Model: Model PL-MF		Date: 2-Oct-06	No.: MG157001
Modified Article: Transfer Roller		Prepared by: H.K.	
From: Technical Service Dept., GTS Division			
Reason for Modification:	<input type="checkbox"/> Parts catalog correction <input type="checkbox"/> To facilitate assembly <input type="checkbox"/> Part standardization	<input checked="" type="checkbox"/> Vendor change <input type="checkbox"/> To improve reliability <input type="checkbox"/> Other	<input type="checkbox"/> To meet standards ()

Change: The material of the transfer roller was changed.

Reason: Vendor change

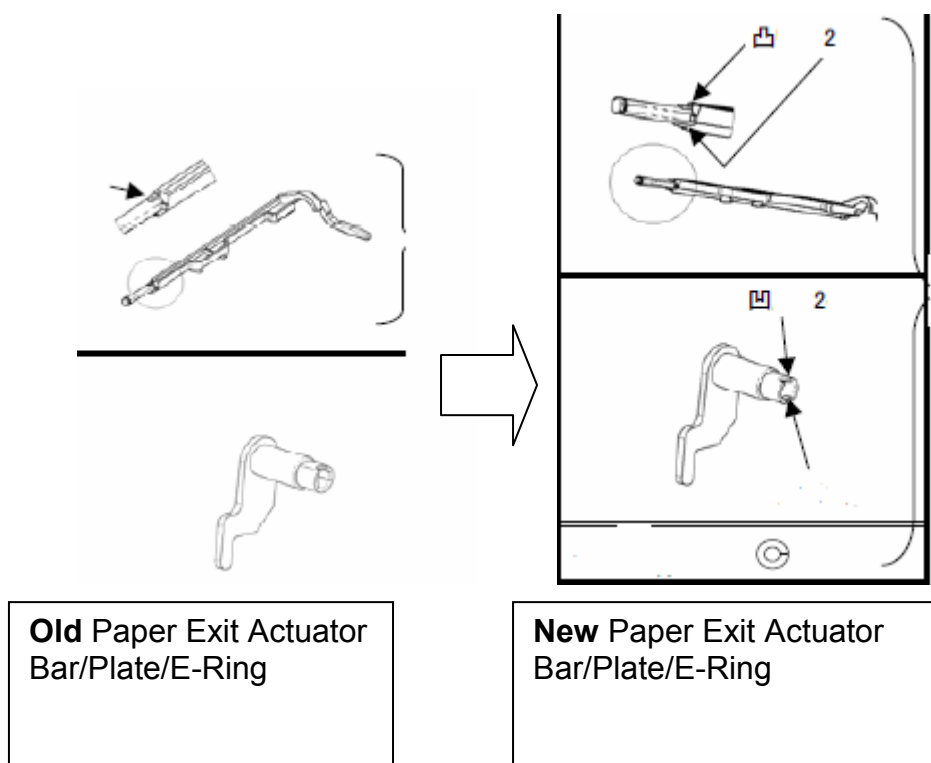
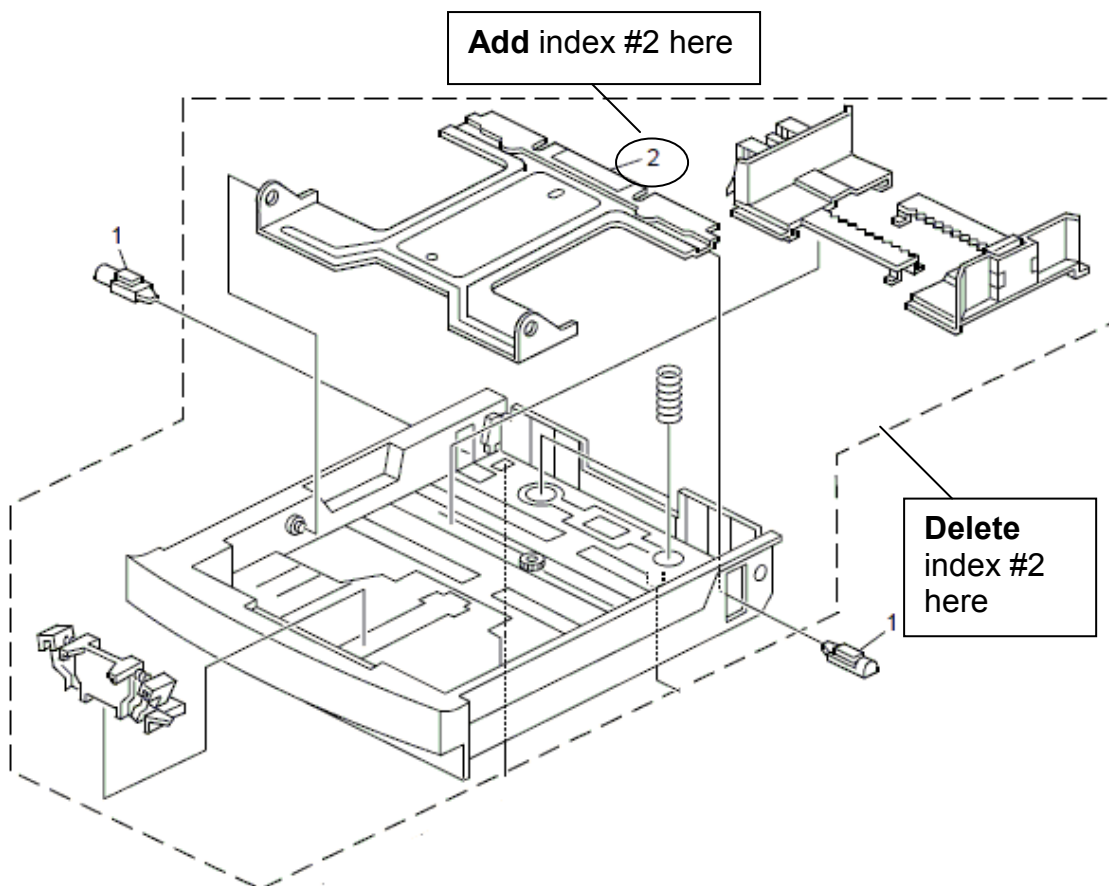
- 1) The shapes of the paper exit actuator (V128497) and bar (not a service part) were changed.
- 2) The new actuator and new bar were combined into one service part (V128720).

Reason: To facilitate assembly.

Index #30

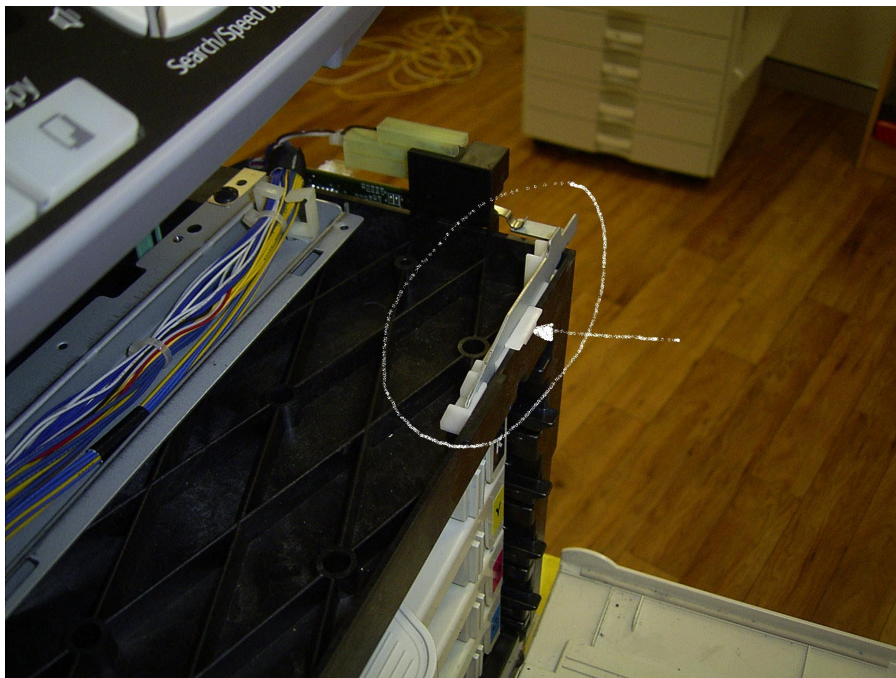
Change/Reason: The part in the table was missing from the Parts Catalog.

P/N V128721 SL5F LOCK LEVER ASS'Y (Metal & Plastic parts)

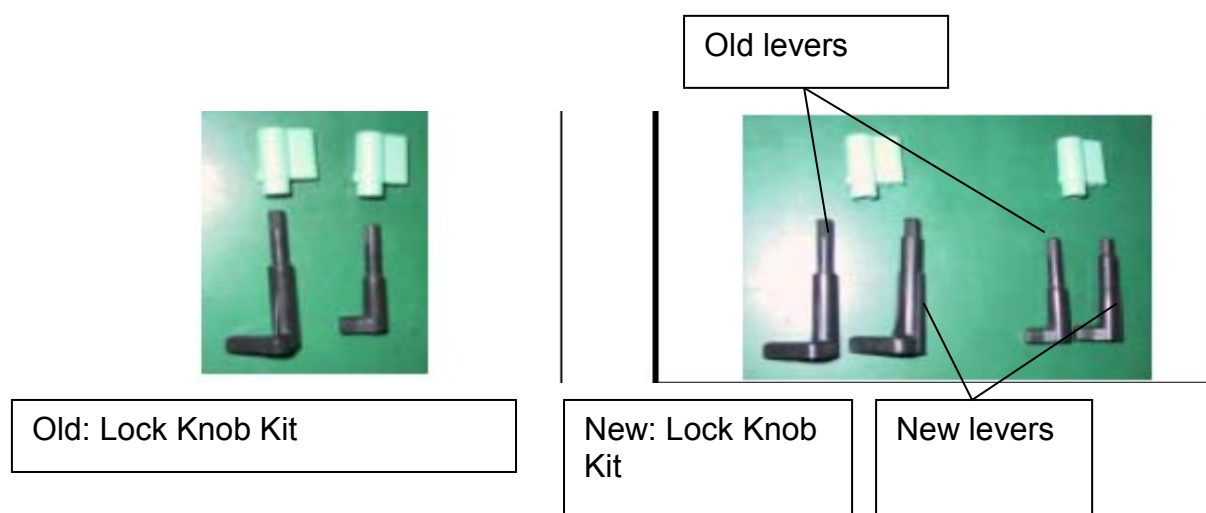
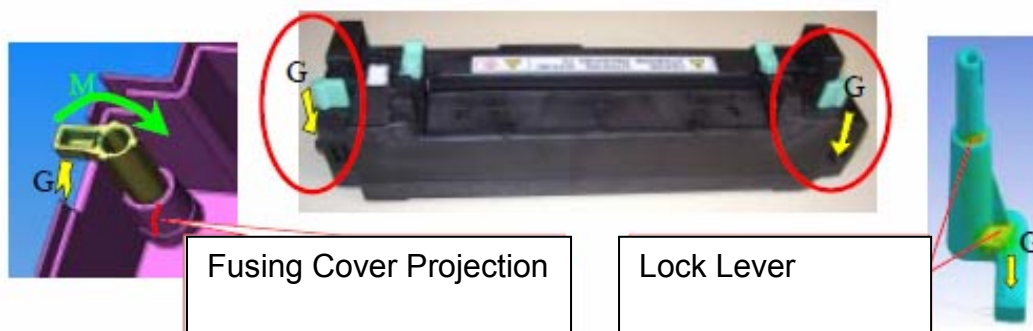
Change: The shapes of the fusing cover projection and lock lever were changed.

Reason: To increase the durability of these parts.

Important: If the old top fuser cover needs to be replaced, install the new top fuser cover **together with** the new lock levers in the new lock knob kit.

Note: The new lock knob kit contains both the old and new lock levers, so that you can replace the lock knob.

A: Shape changed
B: Rib added
C: Rib extended
